OUR REF: 6349
YOUR REF: COM/2025/97

RE: RESPONSE TO COUNCIL INFORMATION REQUEST – COM/2025/97

AT: 1 HIGHLANDS STREET, STAPYLTON QLD 4207 (BAL LOT 505 SP316171)

3. Design of off-street parking facilities

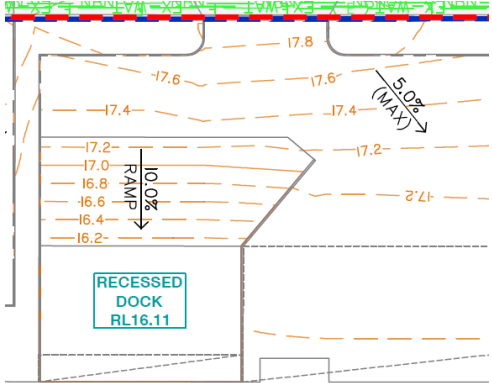
To demonstrate compliance with Acceptable solution and Performance criteria AS3.1/PC 3 of the Car Parking, Access and Transport Integration Constraints code, the applicant is requested to provide amended drawings which address the following:

- a) Show fully dimensioned pedestrian sight triangles on the exit side of each access driveway designed in accordance with Figure 3.4 of AS2890.2:2018. The pedestrian sight triangles must be annotated as follows "Pedestrian sight triangles to be kept clear of all obstructions to visibility. Low level landscaping permitted to a maximum mature height of 500mm above driveway level".

- b) In parking aisles which exceed 6 car parking spaces on each side, provide a turnaround bay to allow vehicles to exit the aisle in a forward gear when all spaces are occupied.

- c) In the northern and southern parking aisles which exceed 100m in length, show humps in accordance with Section 4.9(a) of AS2890.1:2004.
- d) The submitted swept path analysis shows an AV manoeuvring over a recessed loading dock area. The applicant is requested to confirm the grades of the manoeuvring areas and recessed docks to ensure that the AVs are not manoeuvring over a significant drop.

- e) Number all car parking spaces for ease of reference. A potable water supply network capacity assessment for the proposed development. The capacity of the existing system (considering other existing development approvals) must be assessed, and any required augmentation works shall be identified as a result of the development's additional water usage. The assessment must adhere to the SEQ Water Supply and Sewerage Design and Construction Code and the Water Supply and Sewerage Infrastructure Plan.

Table 2. Item 3 Targeted Response Table	
Council Item	GDP Response
a) Show fully dimensioned pedestrian sight triangles on the exit side of each access driveway designed in accordance with Figure 3.4 of AS2890.2:2018. The pedestrian sight triangles must be annotated as follows "Pedestrian sight triangles to be kept clear of all obstructions to visibility. Low level landscaping permitted to a maximum mature height of 500mm above driveway level".	The architectural plans have been updated to include the sight triangles at all exits and have been annotated accordingly. The amended plans have been provided in Attachment A .

b) In parking aisles which exceed 6 car parking spaces on each side, provide a turnaround bay to allow vehicles to exit the aisle in a forward gear when all spaces are occupied.	The plans have been amended to show a turnaround bay at the end of parking aisles that exceed six metres, without circulation. These turnaround bays have been illustrated in the amended plans have been provided in Attachment A.

c) In the northern and southern parking aisles which exceed 100m in length, show humps in accordance with Section 4.9(a) of AS2890.1:2004.	The proposal plans have been amended to include speed humps designed in accordance with the relevant Australian Standard in parking aisles exceeding 100 metres in length.

d) The submitted swept path analysis shows an AV manoeuvring over a recessed loading dock area. The applicant is requested to confirm the grades of the manoeuvring areas and recessed docks to ensure that the AVs are not manoeuvring over a significant drop.	The swept path analysis provided in the Traffic Impact Assessment Report shows the clearance envelope of the swept path intersecting with the very edge of the recessed dock. Whilst this clearance envelope is the only part of the swept path intersecting, it is important to identify the slope intersected to ensure utmost clarity. As pictured in the extract below (see Appendix F – Engineering Services Report of lodged application), the grade of the site does not change level where the intersection occurs and therefore the area would maintain the same gradual slope where the swept path is located.  Further, the loading docks have been designed in accordance with change in grade criteria in AS2890.2 – Off-street Commercial Vehicle Facilities.

e) Number all car parking spaces for ease of reference. A potable water supply network capacity assessment for the proposed development. The capacity of the existing system (considering other existing development approvals) must be assessed, and any required augmentation works shall be identified as a result of the development's additional water usage. The assessment must adhere to the SEQ Water Supply and Sewerage Design and Construction Code and the Water Supply and Sewerage Infrastructure Plan.	The proposal plans have been amended to include numbered car parking spaces. These amended plans have been provided in Attachment A.
